802.3dj D2.0

Comment Resolution

Electrical Track

Figure 178-2—200GBASE-KR1, 400GBASE-KR2, 800GBASE-KR4, or 1.6TBASE-KR8 link

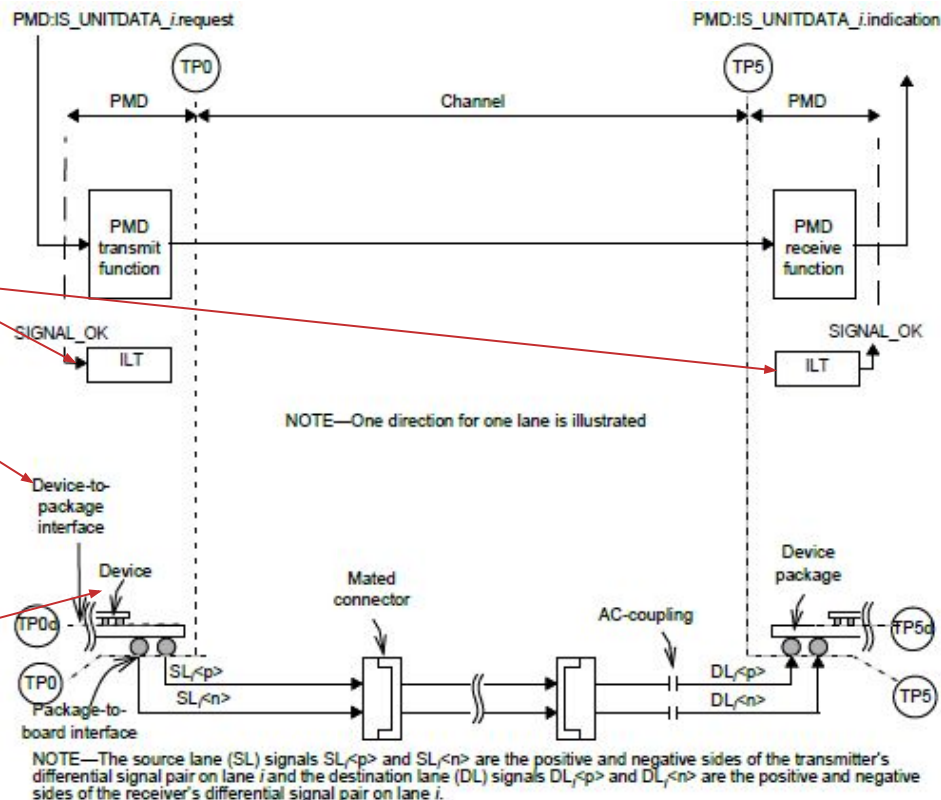
In Figure 178-2 add the ILT function above the PMD transmit and receive functions. Show the SIGNAL_OK as an input to the ILT function at the left side and as an output to the ILT function in the right side (refer for example to Figure 180-2)

Figure 178-2. The interface at TP0 is helpfully labelled as "package-to-board interface". A similar label would be helpful at TP0d.

In Figure 178-2, make the following changes:

Show the PMD ending and "channel" beginning at TP0 and TP5.

Add a label at TP0 and TP5 "MDI".

Change label pointing to the die on the left side of the Figure 178-2 to "Die".

- 92: Add the ILT function & SIGNAL_OK above PMD function.
- 302: ~~Label “Die to package interface at TP0d. Also apply to Figure 176C 2.”~~
- 303: Show channel going from TP0 to TP5. Add “MDI” at TP0 & TP5. (and in Figure 176C-2)
- 304: ~~Change label on die at left from ‘device’ to ‘die’.~~
- 640: Change subclause title to “Reference test points”.

Editor's recommendations: Implement the changes listed on this slide (not including the change of “device” to “die”).

Figure 178-3—Transmitter test fixture and test points

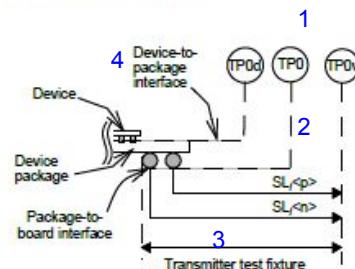
Figure 178-3. It is ambiguous where the test fixture begins. The intent is that the test fixture begins at TP0. Also, it would be good to properly describe the TP0d interface. This figure nor the text definitely define the start and end points of the test fixture.

In Figure 178-3 do the following:

Add test point TP0 at the "package-to-board interface". 1

Add a label at the TP0d interface "die-to-package interface". 4

Updated figures and text.

Unless otherwise noted, measurements of the transmitter are made at the output of a test fixture (TP0v) as shown in Figure 178-3 and described in Annex 163A. The transmitter test fixture is between TP0 and TP0v. An example test fixture is described in Annex 163B.

176D.8.2 Effective return loss (ERL)

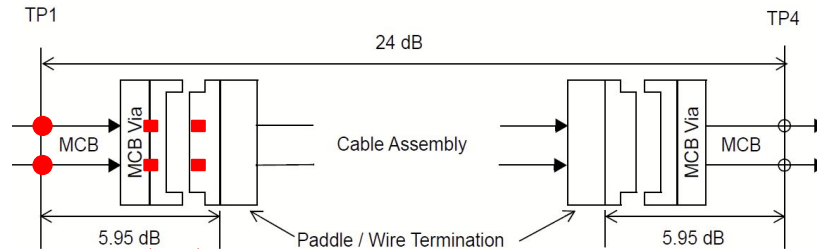
CI 176D	SC 176D.8.2	P 752	L 29	# 361
Ghiassi, Ali Ghiasi Qunatum/Marvell				
Comment Type	TR	Comment Status	D	(Electrical) Tfx
Line 30 says that "Tfx equal to twice the test fixture delay", statement is not clear.

<i>SuggestedRemedy</i>	
Tfx for measurement of Host Input/Output is twice the HCB delay. Tfx for measurement of Module Input/Output is twice the MCB delay. Suggest to move Tfx into the table and make the above as footnotes in the table. We shouldn't state in IEEE standard "Tfx is provided by the test fixture provider", what about if fixture supplier doesn't!	
<i>Proposed Response</i>	<i>Response Status</i> W
PROPOSED REJECT. The test fixture delay is defined in detail in the second paragraph of 176D.8.2 for both host and module measurements. Based on these definitions, the statement should be clear. The suggested remedy does not match the second paragraph and would not improve clarity. The statement that Tfx is provided by the test fixture provider" was added by the response to comment #199 against D1.1, see < https://www.ieee802.org/3/dj/comments/D1p1/8023dj_D1p1_comments_final_clause.pdf#page=77 >. It should be understood as a requirement. The suggested remedy does not provide an alternative phrasing for this statement.

PROPOSED REJECT.
The test fixture delay is defined in detail in the second paragraph of 176D.8.2 for both host and module measurements. Based on these definitions, the statement should be clear.
The suggested remedy does not match the second paragraph and would not improve clarity.
The statement that Tfx is provided by the test fixture provider" was added by the response to comment #199 against D1.1, see <
https://www.ieee802.org/3/dj/comments/D1p1/8023dj_D1p1_comments_final_clause.pdf#page=77>. It should be understood as a requirement. The suggested remedy does not provide an alternative phrasing for this statement.

Figure 176D-5—Module compliance points

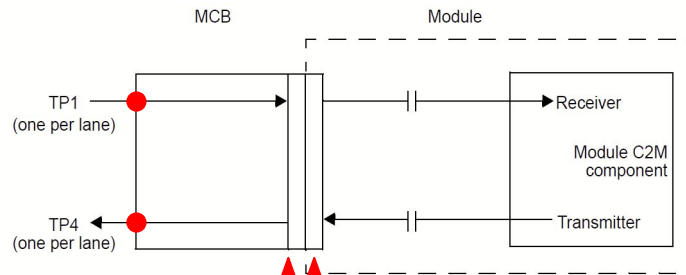
- A: MCB connector pads
- B: Receptacle mating point (Cable/HCB pads/Gold Fingers)
- C: Somewhere else?

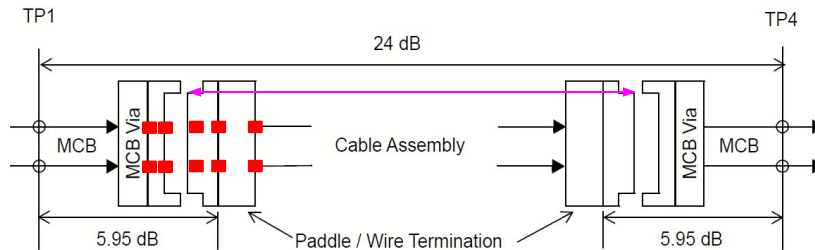
Comment Type T Comment Status D (Electrical) ERL

Reword to remove reference to the mating interface discontinuity; Tfx should include the RF test connector only.

In 176D.8.2 change from:

“For module input and output ERL, the test fixture delay is defined as the propagation delay between the test connector and the module-facing connection, excluding the mating interface discontinuity.”

“For module input and output ERL, the test fixture delay is defined as the propagation delay between the test fixture's coaxial connector and the discontinuity of the MDI connector”.

Change other instances of “test connector” to “test fixture's coaxial connector”.

CR Test Fixture

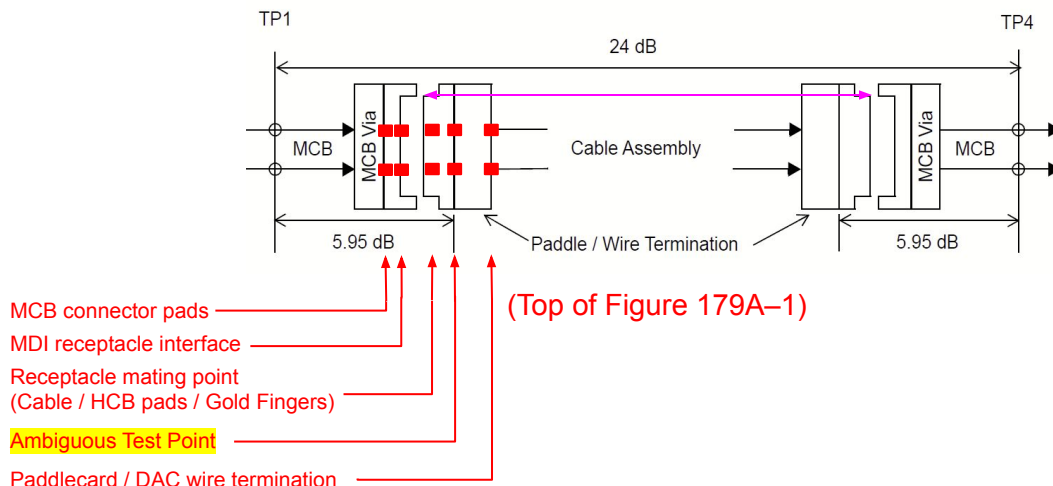
CI 179A	SC 179A.5	P 821	L 4	# 658
Swenson, Norman		Nokia, Point2		
Comment Type	TR	Comment Status	D	(Electrical) CR test fixture
What is the extra rectangle labeled Paddle/Wire Termination shown in Fig. 179A-2 that is not shown in the mated test fixtures in Fig 179A-1? It is not explained in the text.				
Suggested Remedy				
Clarify				
Proposed Response		Response Status W		
PROPOSED ACCEPT IN PRINCIPLE.				
The rectangle and labels "Paddle/Wire Termination" serve as demarcation of the cable assembly and the host channel, in Figures 179A-1, 2, and 3. The "Paddle" and "Wire Termination" are structures associated with the cable assembly, and are not necessarily present in an HCB (or Mated Test Fixture). The labels are used to identify specific structures that are not documented elsewhere in the figure.				
These figures provide illustration as appropriate within an informative Annex. Similar figures with the same features are included in in Annex 162A, added by IEEE Std 802.3ck.

CI 179A	SC 179A.5	P 820	L 39	# 289
Heck, Howard		TE Connectivity		
Comment Type	TR	Comment Status	D	(Electrical) CR test fixture
<p>MCB loss specified in the lower left of Figure 179A-1 is not directly measurable as it is currently specified. Indirect measurement methods do not provide the necessary accuracy. The version of the figure in D1.4 was measureable and reverting back to it will resolve the problem. Equation 179B-2 requires modification to make it accurately represent the MCB insertion loss measured with the 2Xthru method</p>

The suggested remedy does not contain sufficient detail for the CRG to discuss a specific change.

ILcd/ILdc

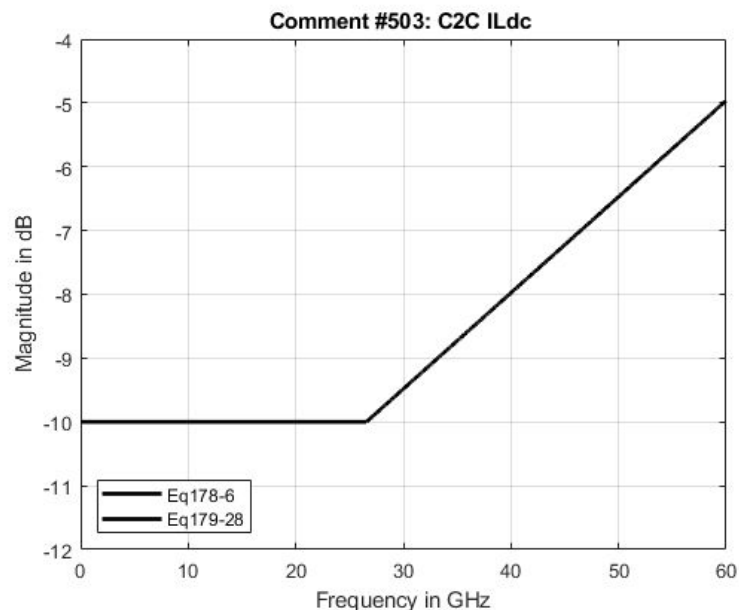
CI 176C	SC 176C.7	P 731	L 17	# 503
Dudek, Mike		Marvell		
Comment Type	TR	Comment Status	D	(Electrical) C2C channel

Add a specification to the channel specification for differential-mode to common-mode conversion with the same equation as used for KR (equation 178-6) or as used for CR cable (equation 179-28)

The comment addresses an inconsistency in the specifications. ILcd and ILdc are specified for the KR channel but not for the C2C channel.

In Table 176C-6, add rows for ILcd and ILdc referring to the same equations as in Table 178-11.

Implement with editorial license.
